**Addendum #1**  
**2020 Roadway Improvement Project**  
**“Cambridge Drive Neighborhood”**  
**Bid No. 20-15**  
**Town of East Hartford**

**February 28, 2020**

The following summarizes the revisions to the Bid Documents included in Addendum #1 for the 2020 Roadway Improvement Project (Bid No. 20-15).

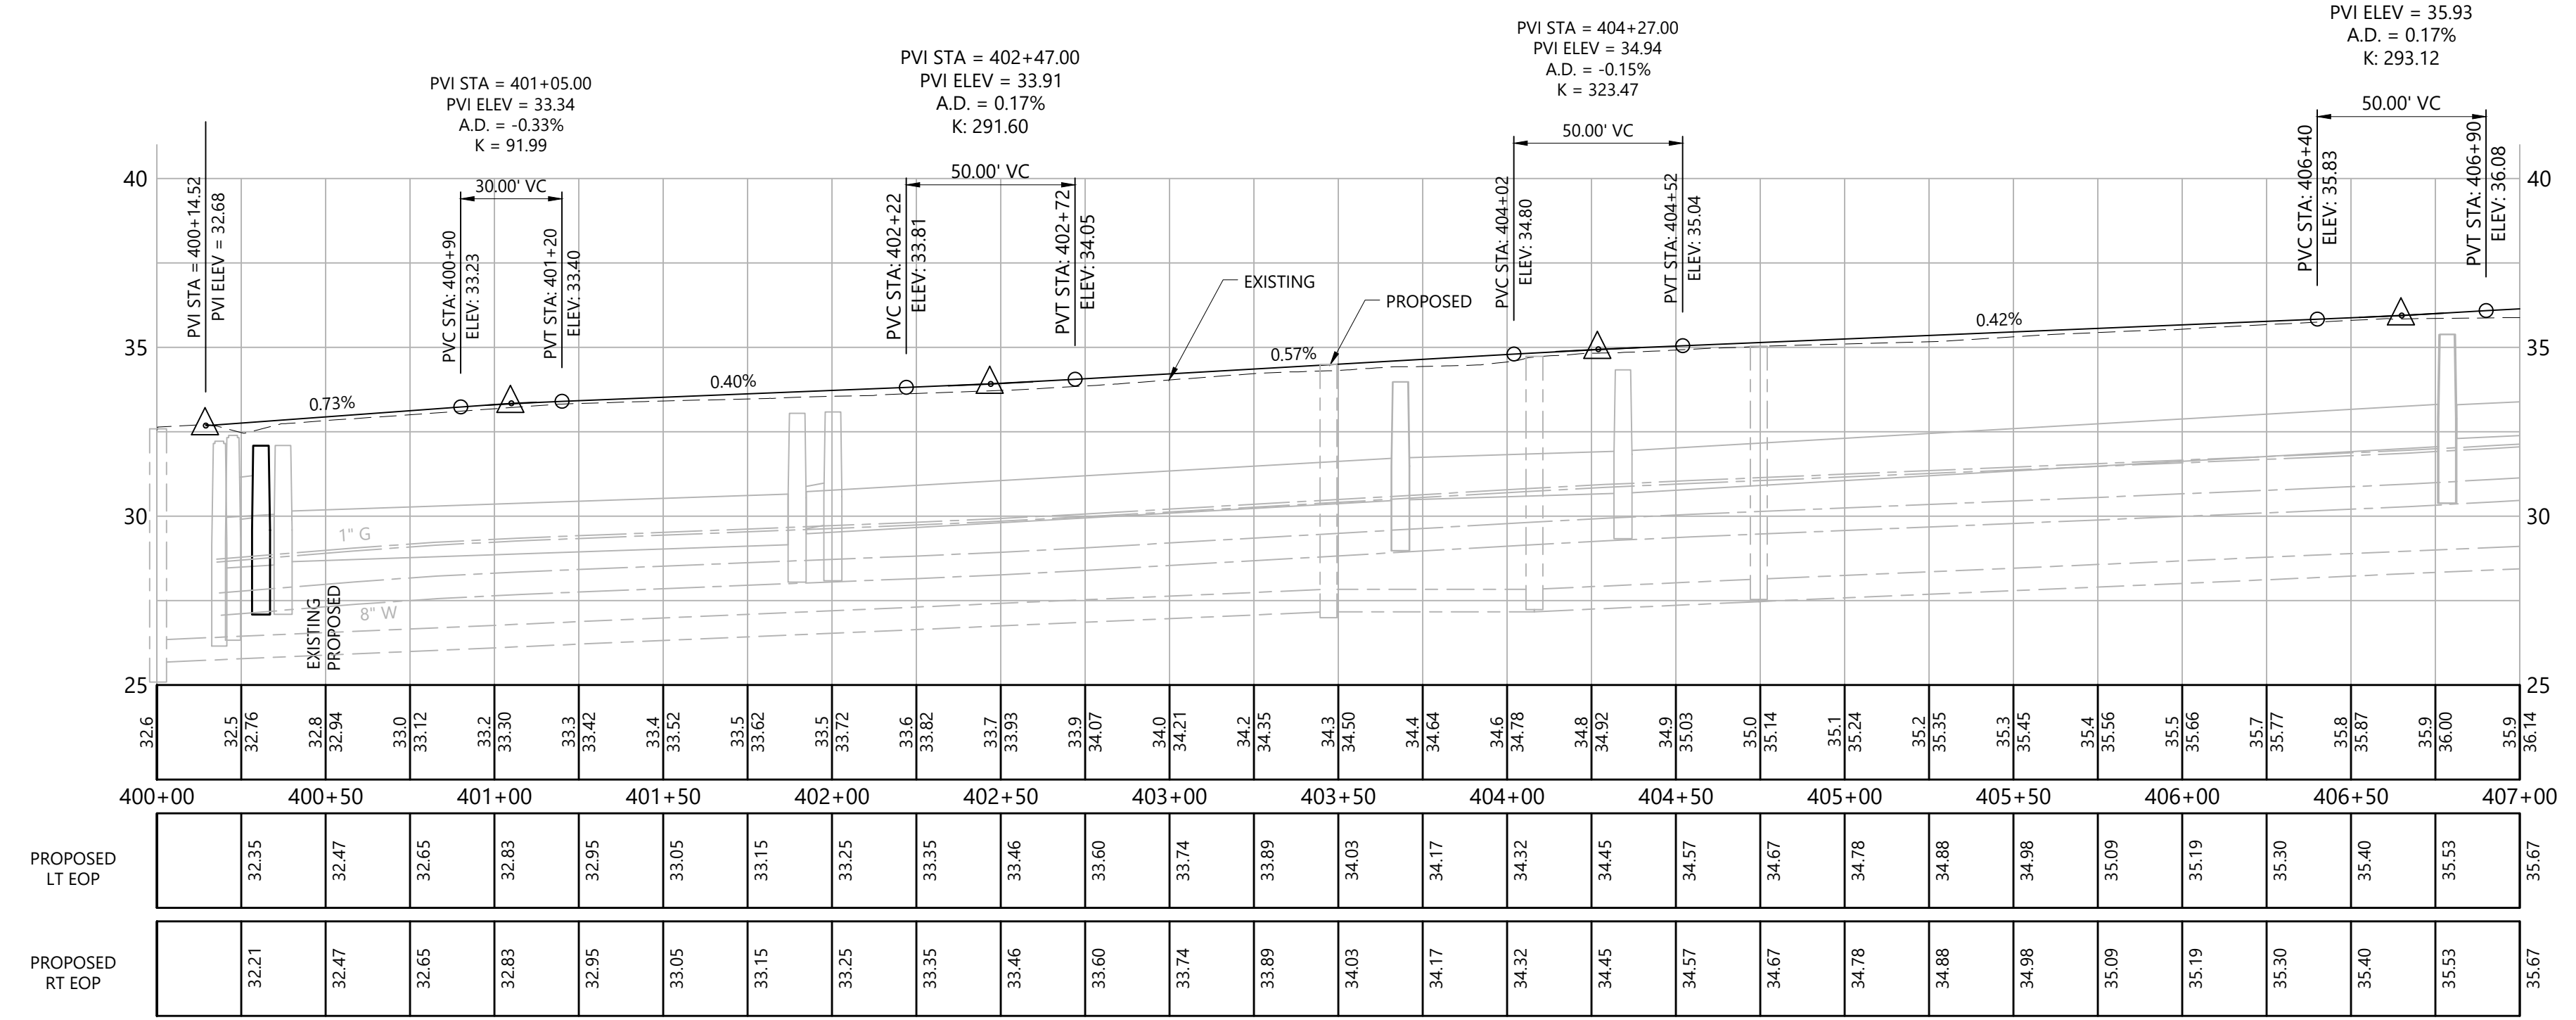
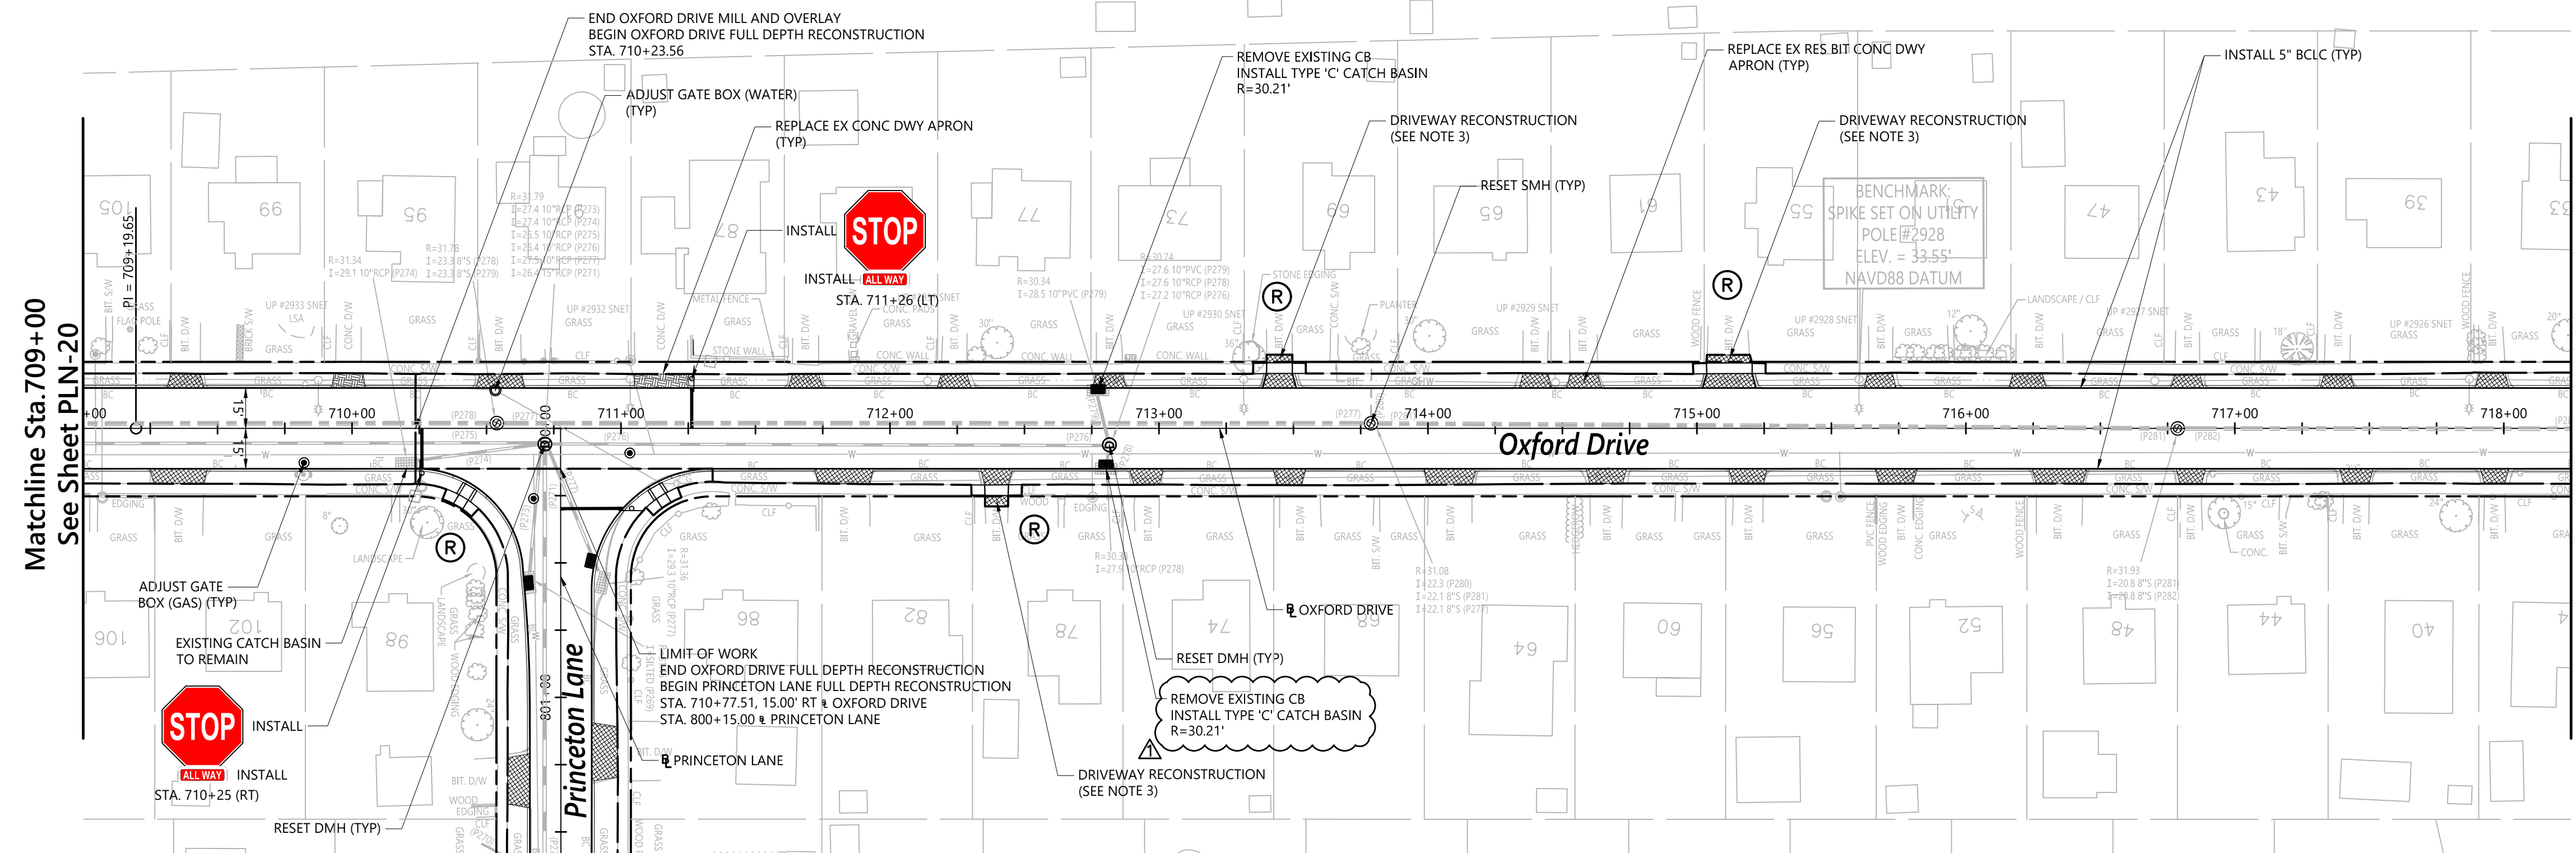
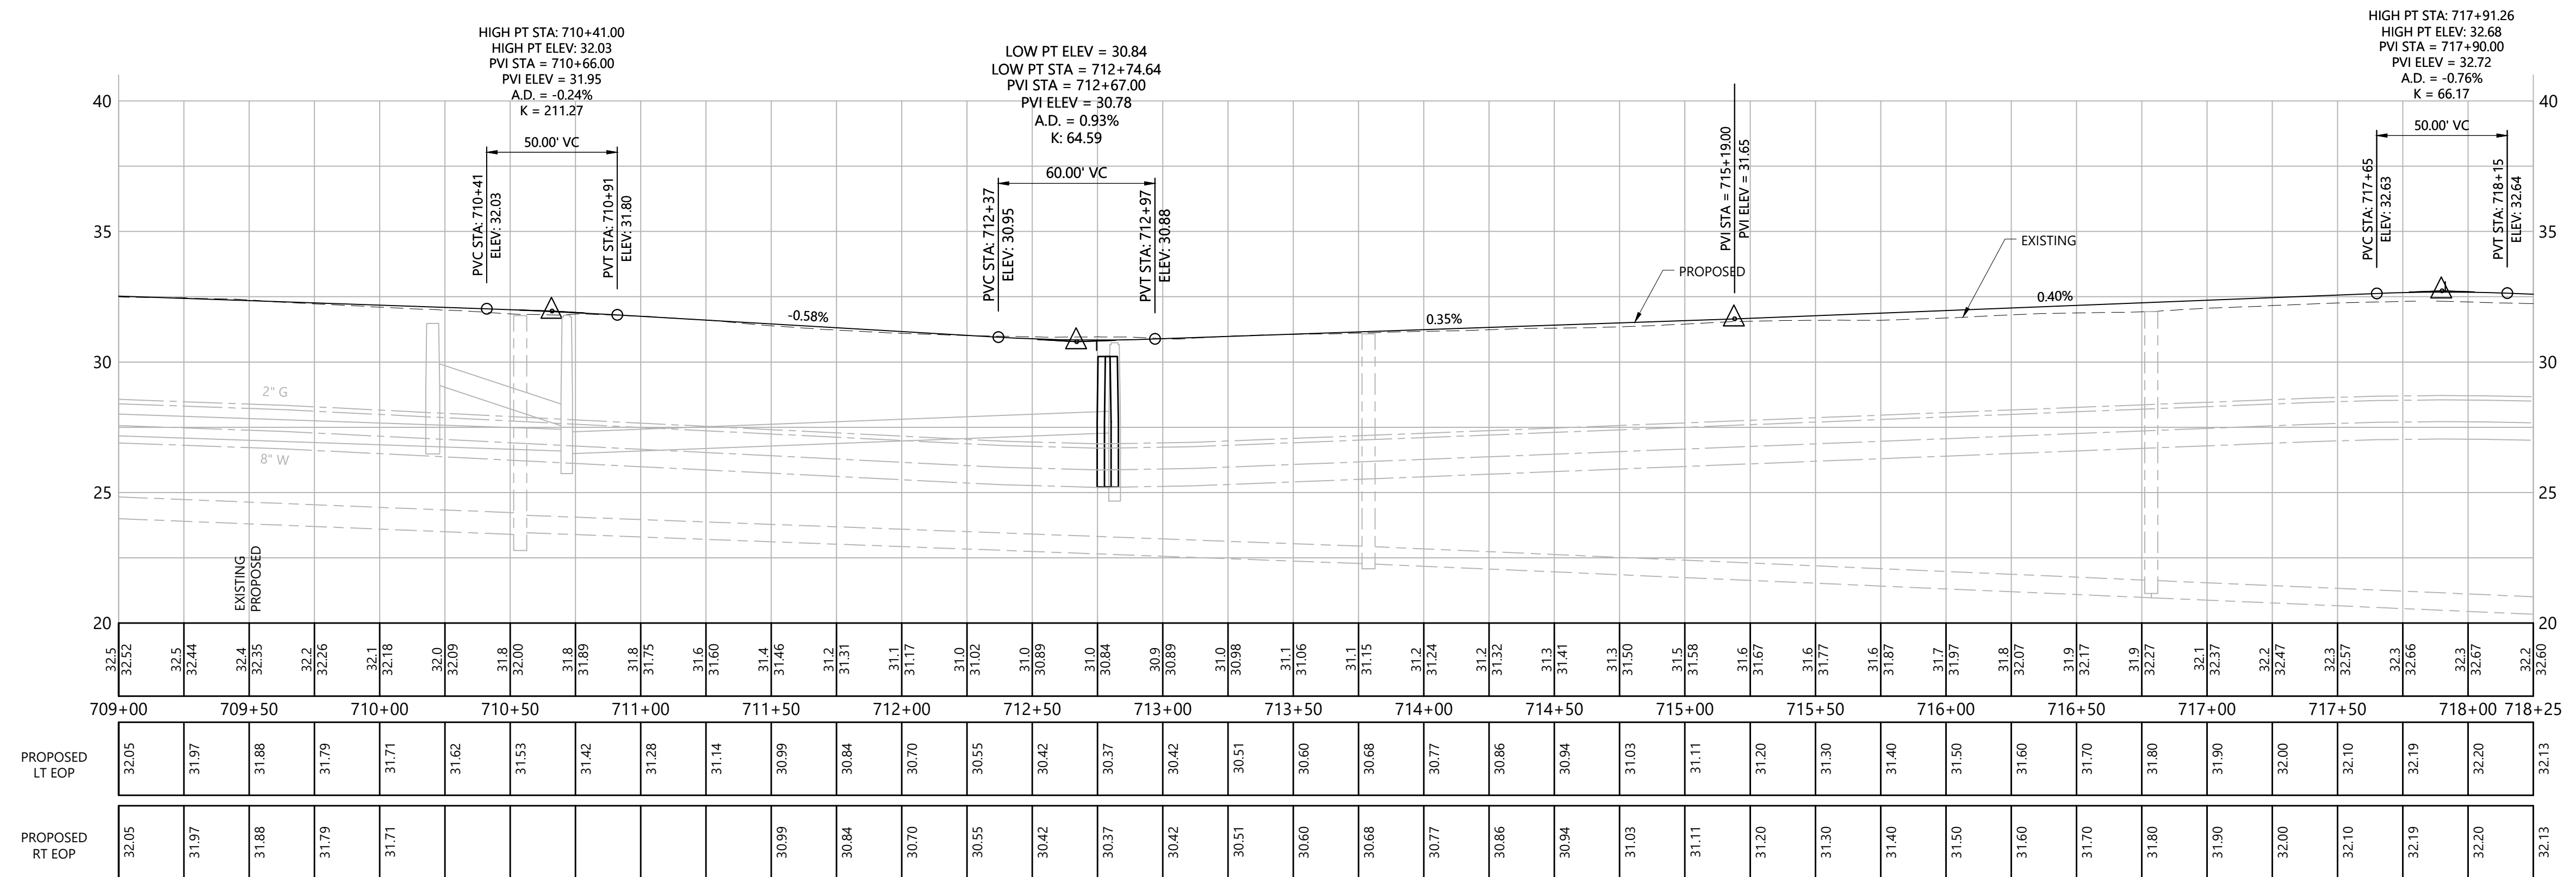
- Replace plan sheet 089 of 294 to reflect revised sidewalk ramp layout and curb layout.

HORIZONTAL SCALE IN FEET	 VERTICAL SCALE IN FEET	DESIGNER: JRE DRAFTER: TJM CHECKED BY: BAA APPROVED BY: SON	 Engineers Scientists Planners Designers ISSUED FOR CONSTRUCTION DATE: JANUARY, 2020	 PROJECT TITLE: <b>CAMBRIDGE DRIVE NEIGHBORHOOD ROADWAY IMPROVEMENT PROJECT VARIOUS LOCATIONS</b> CADD FILENAME: PLN--JEFFERSON--4241300 - ADDENDUM #1.DWG	TOWN: EAST HARTFORD, CONNECTICUT	PROJECT NO.: 42413.00 DRAWING NO.: PLN-13 SHEET NO.: 089 OF 294
REV. DATE DESCRIPTION REVISIONS SHEET NO.	02/27/20 REVISED SIDEWALK RAMP AND CURB LAYOUT 089

PROJECT NO.: 42413.00  
 DRAWING NO.: PLN-21  
 SHEET NO.: 098 OF 294

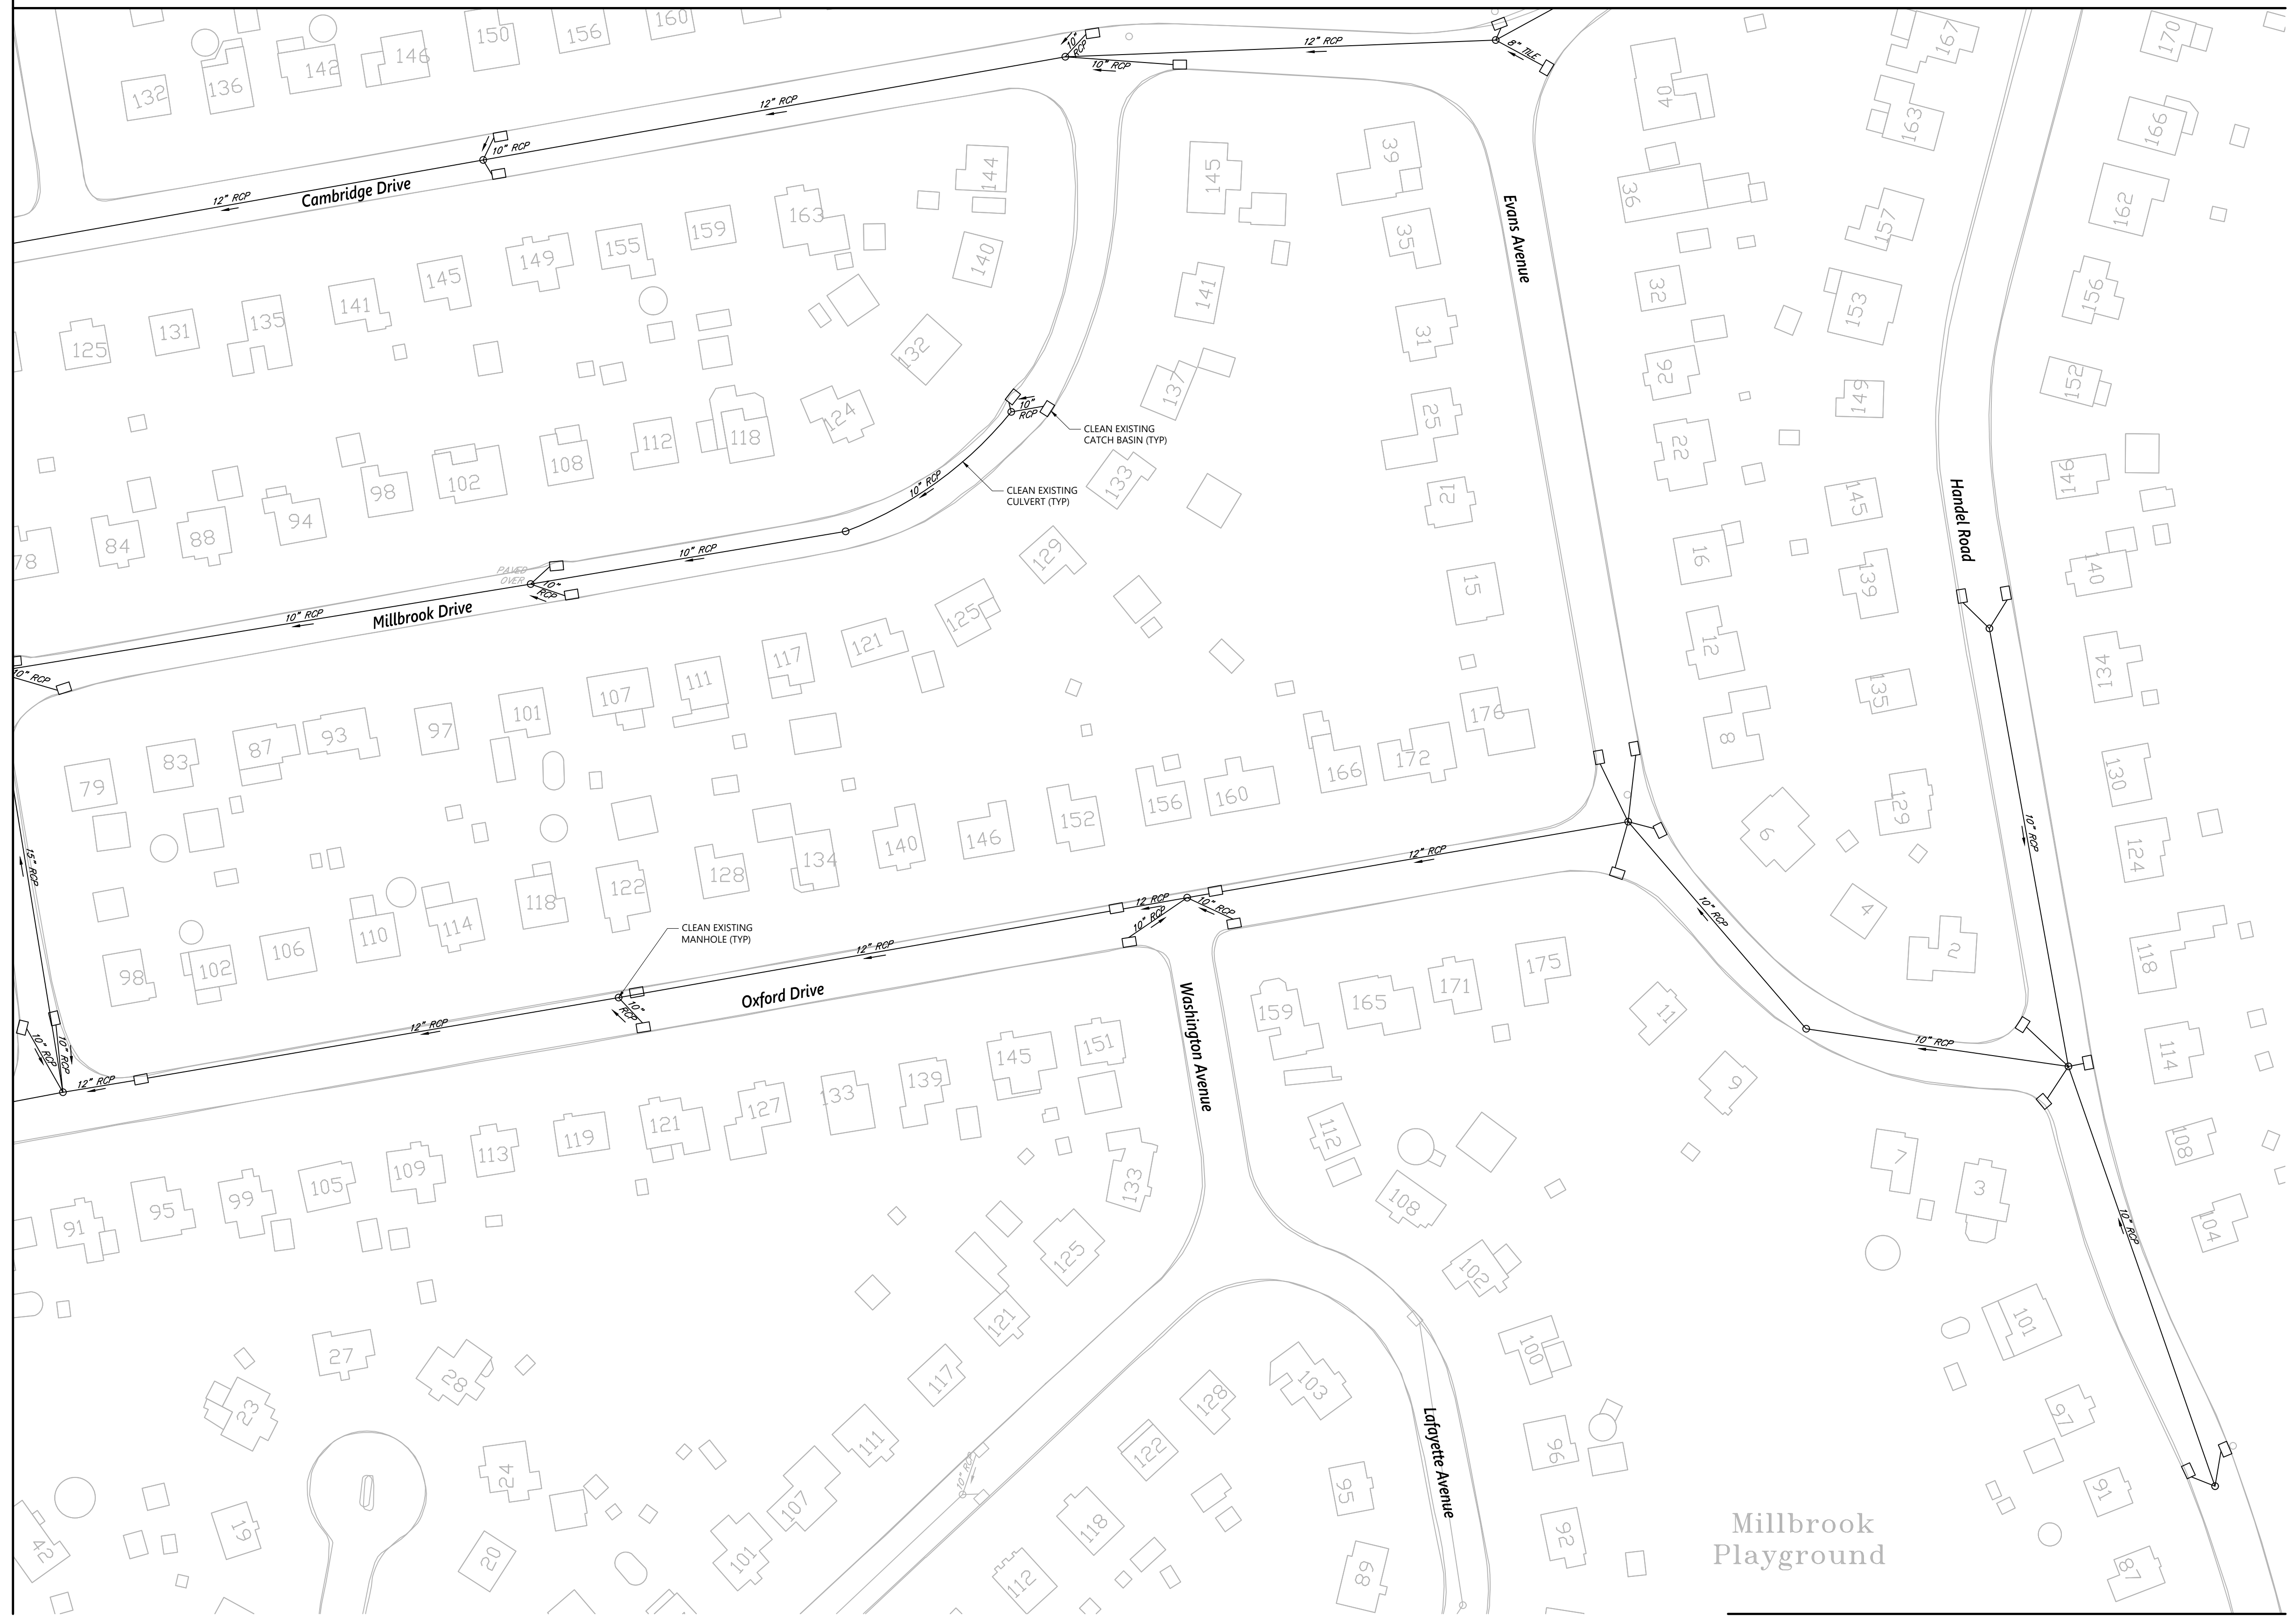
- Replace plan sheet 098 of 294 to reflect a revised rim elevation.

REV.	02/27/20	REVISED RIM ELEVATION	098
DATE		DESCRIPTION	SHEET NO.
